**TO:** City Plan Board

**SUBJECT:** Petition PB-16-34 SUP: Greenberg Farrow, agent for Walmart Stores East, owner. A Special use permit with an intermediate development plan to allow for the construction of a gas station with convenience store. Zoned: MU-2 (12—30 units/acre mixed use medium intensity). Located at 1800 NE 12th Avenue.

### RECOMMENDATIONS/REQUIREMENTS/COMMENT

# SITE DEVELOPMENT PLANS FOR MURPHY OIL USA, INC. GAINESVILLE, FLORIDA

**SITE PLAN**  
WALMART SUPERCENTER #3877  
1800 NE 12 AVE  
GAINESVILLE, FLORIDA

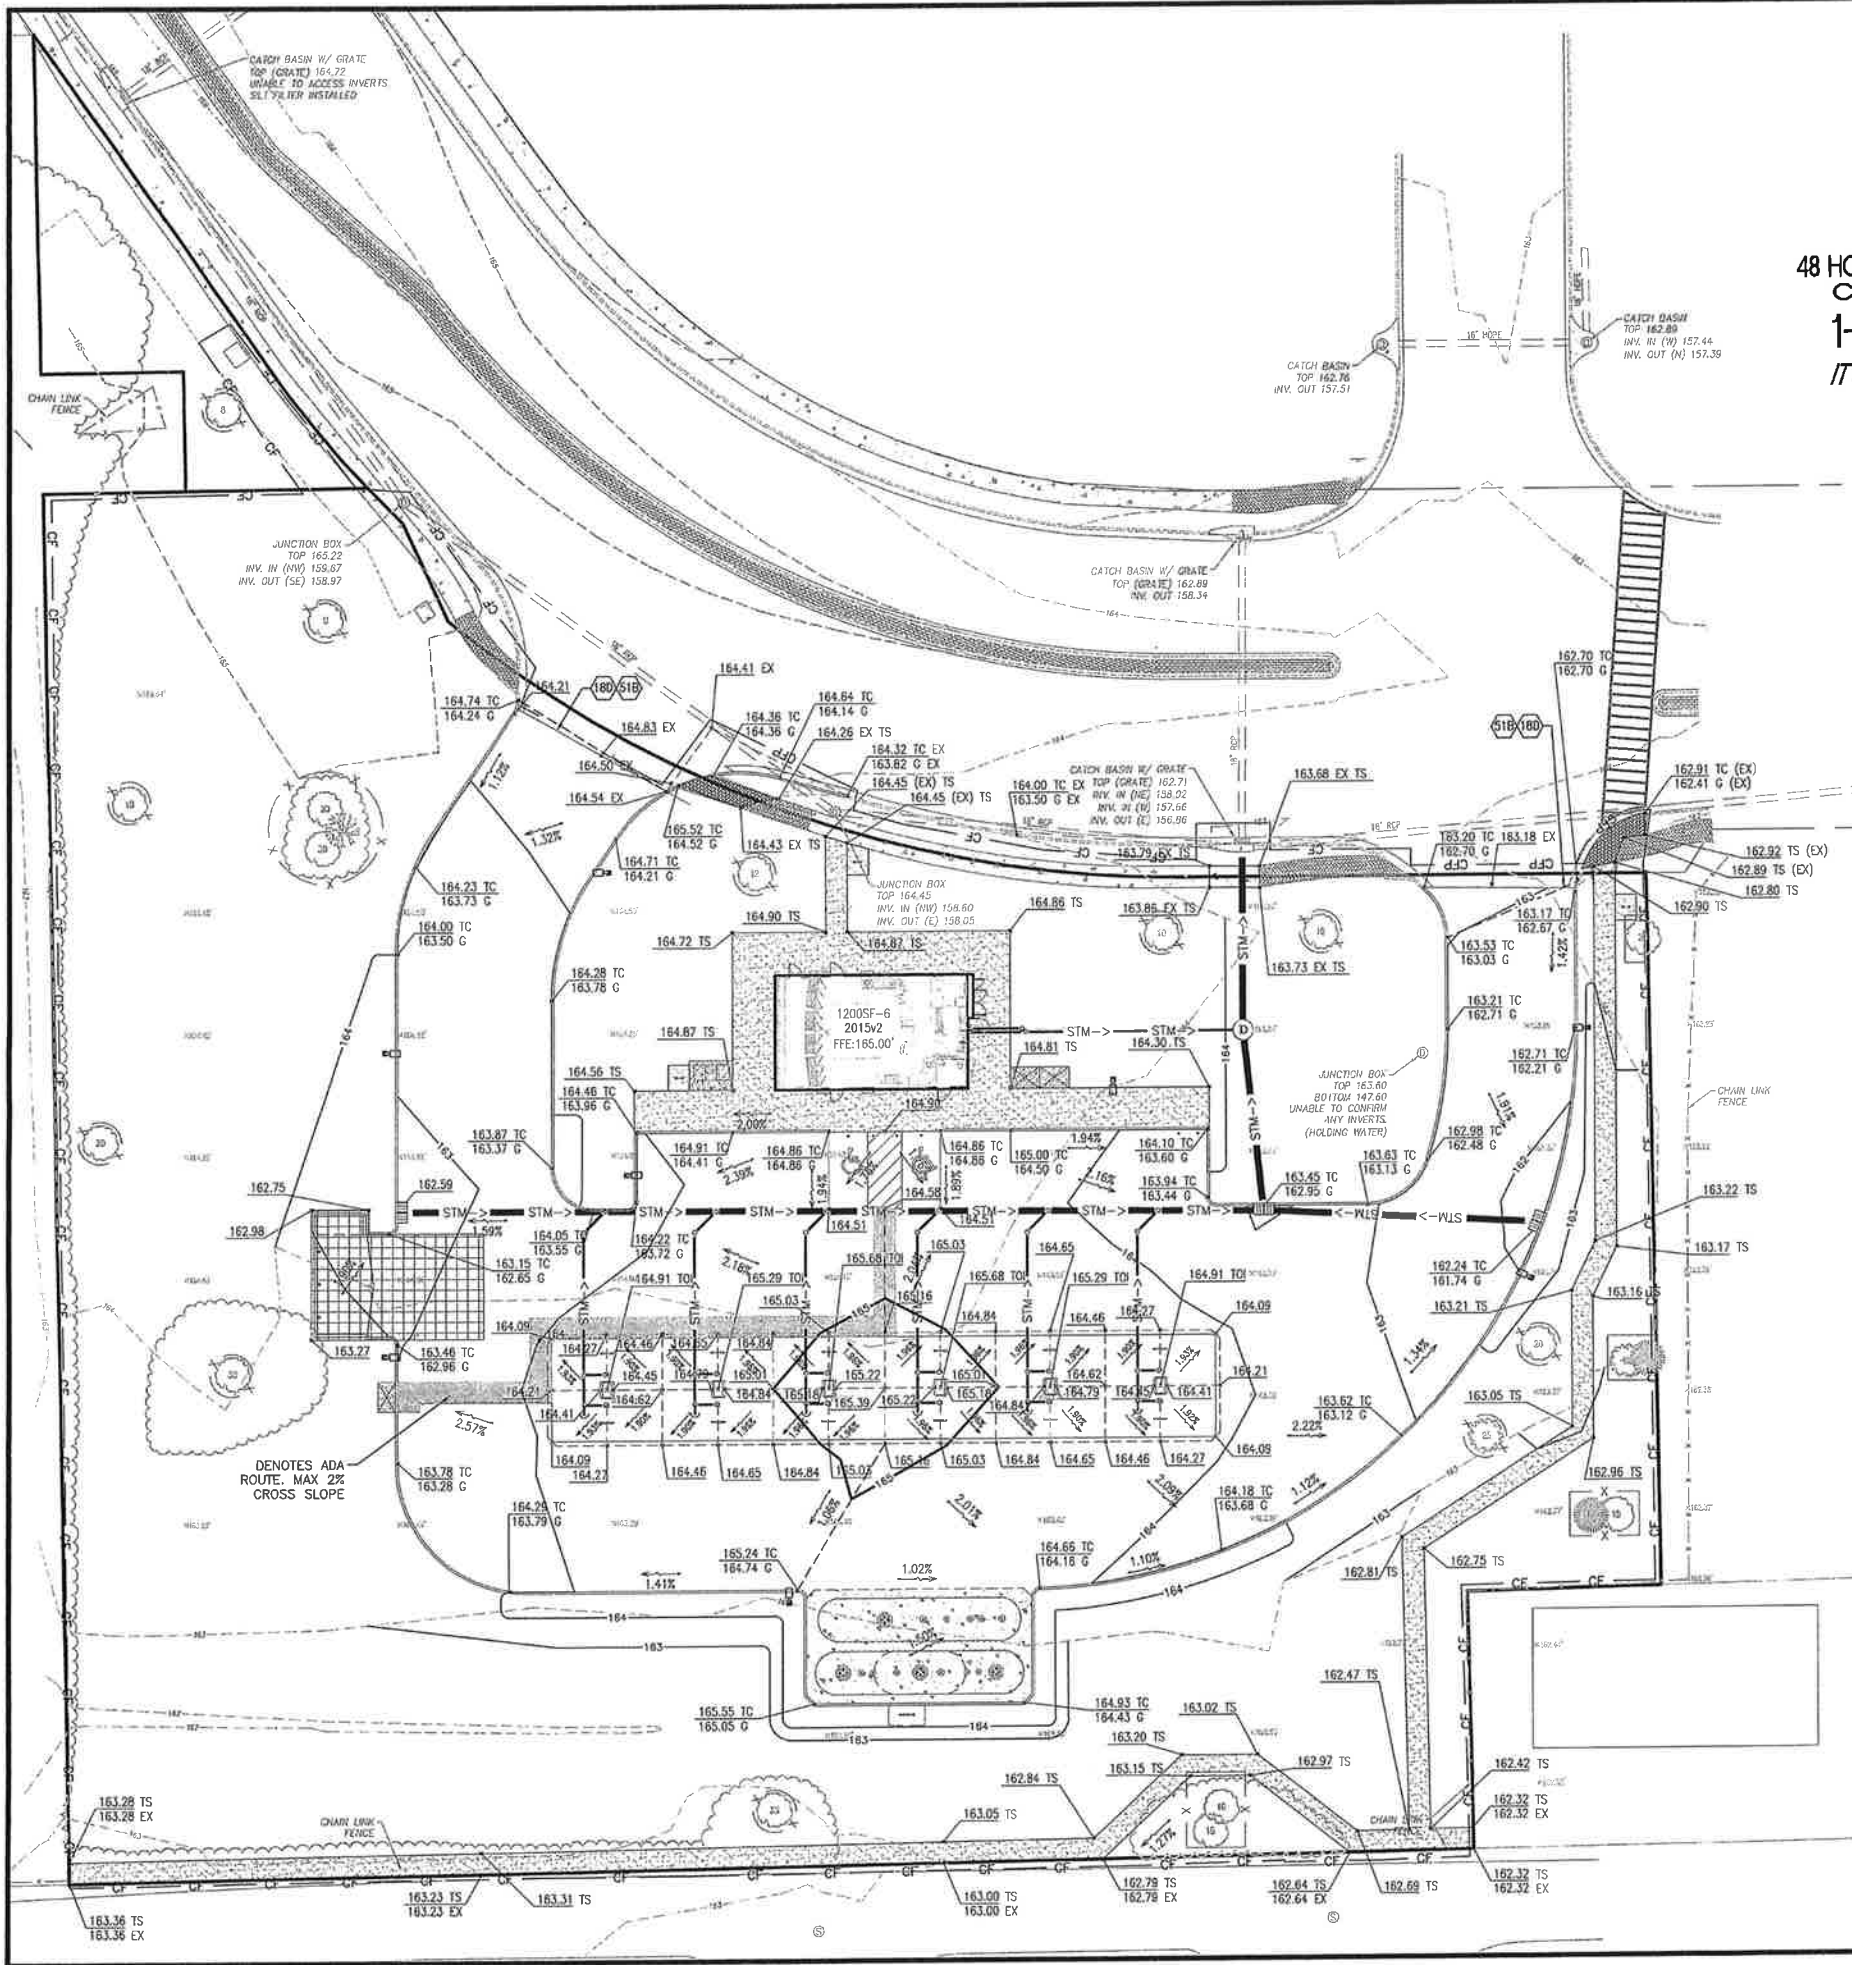
1. Please add the trip generation numbers for the gas station onto sheet C-1 and site the traffic study for the Walmart as the source.

LANDSCAPE

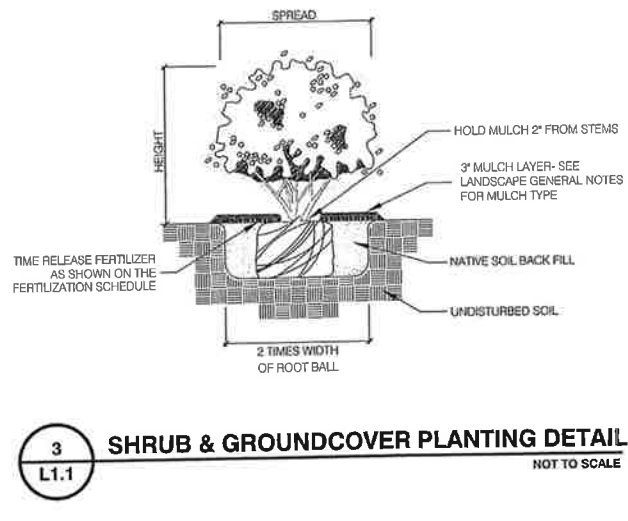
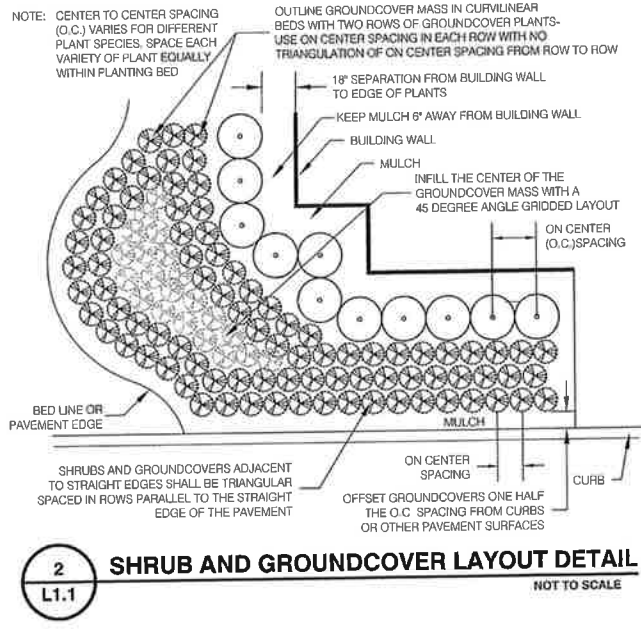
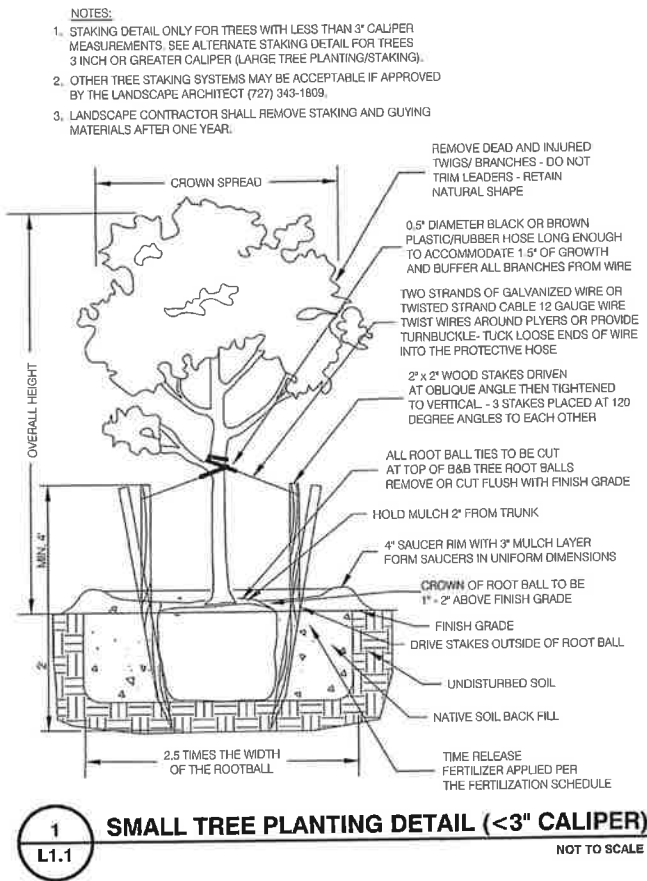
7. It appears that the landscaping provided along the exterior of the vehicular use area may create a safety concern because of its height. Staff recommends a species that would be shorter and provide less screening.

1. Please replace the Red Maple trees with Florida Maple trees.

PHOTOMETRIC  
SITE PLAN

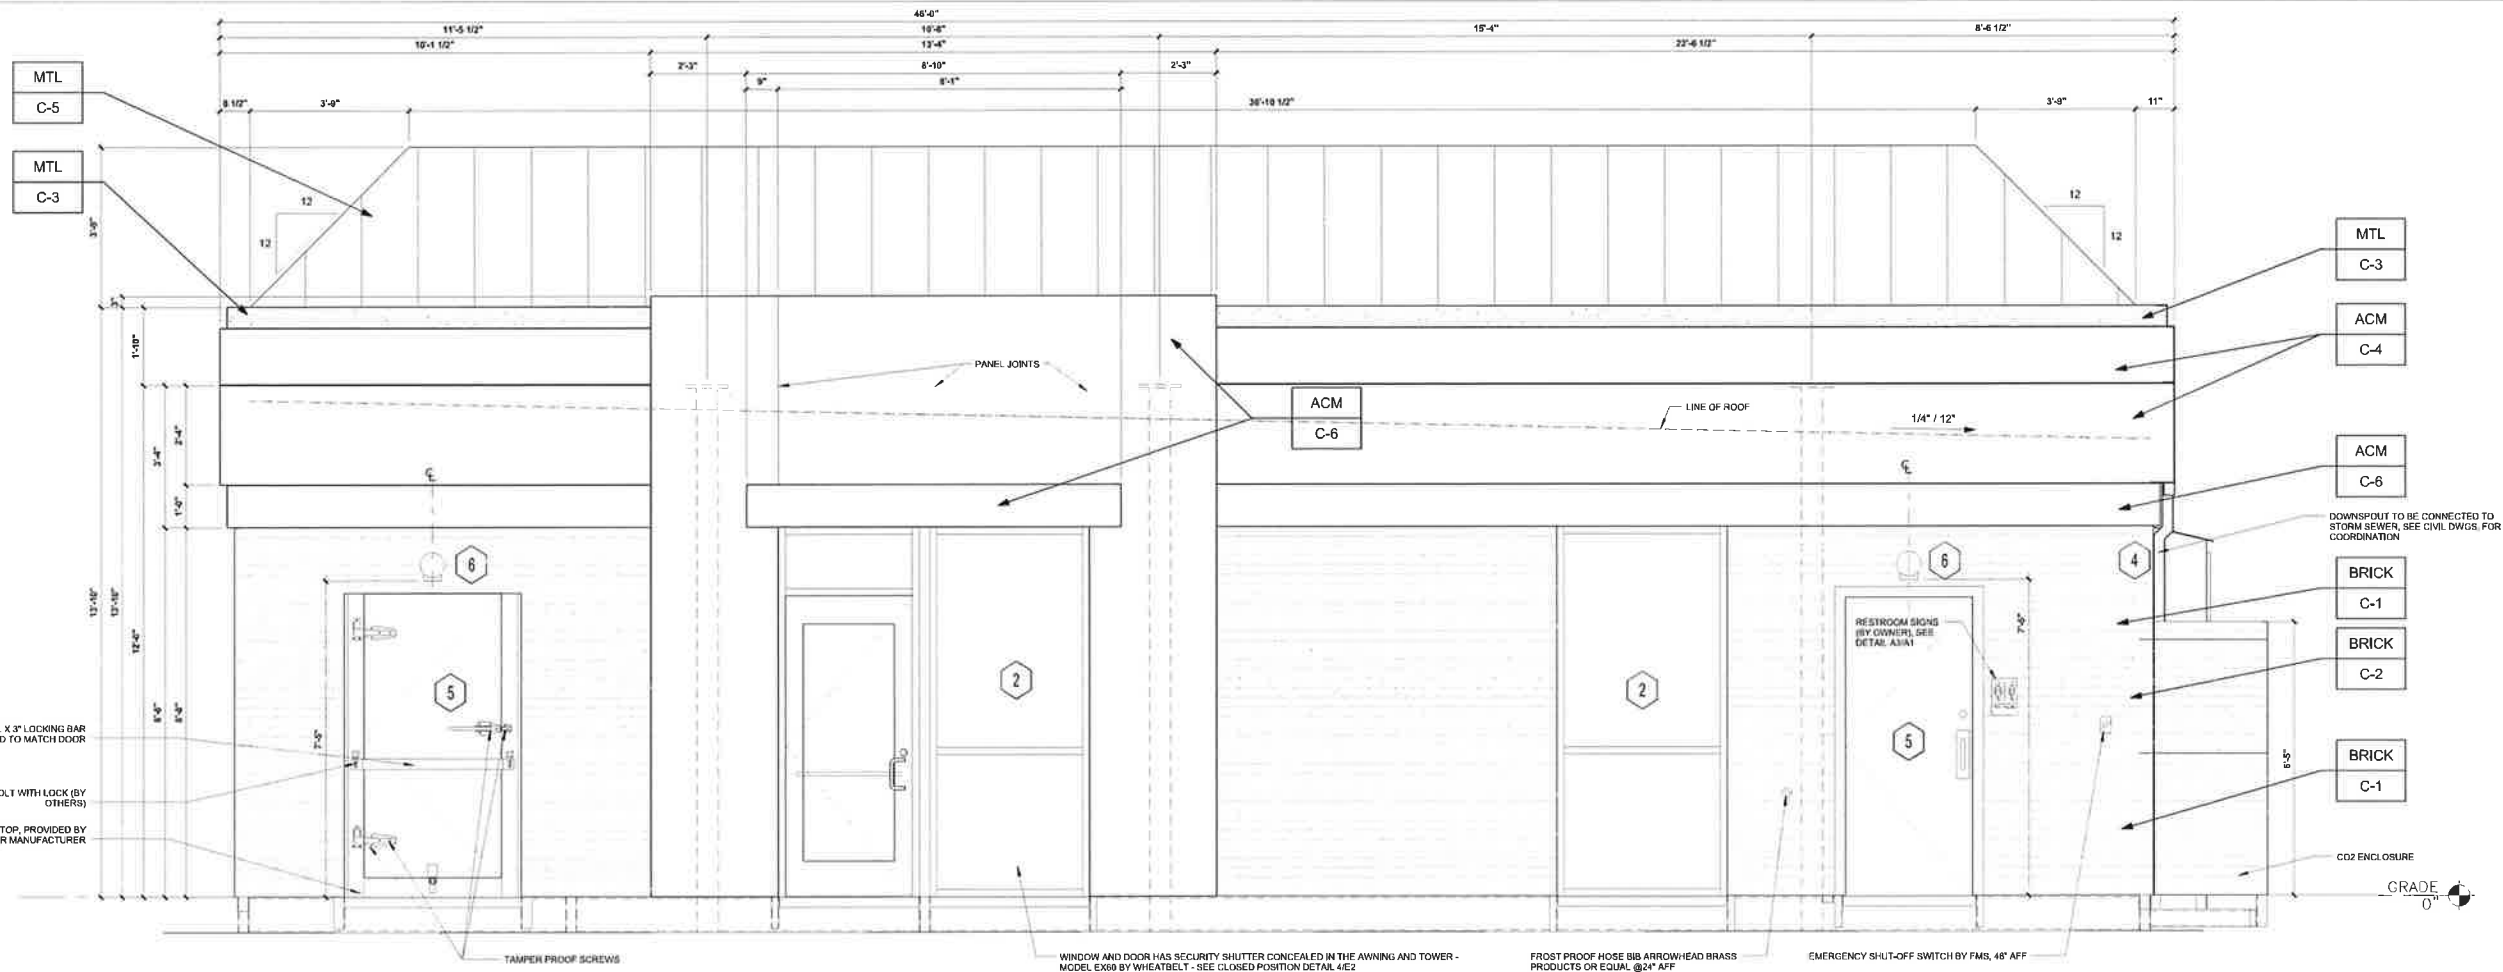
***Condition 4. The photometric plan shall ensure that lighting complies with the requirements of the Land Development Code. Consideration of any waivers shall not allow lighting intrusion and spillover lighting into the adjacent neighborhoods. All light fixtures shall be designed and placed so that there is no direct lighting into the adjacent neighborhoods.***
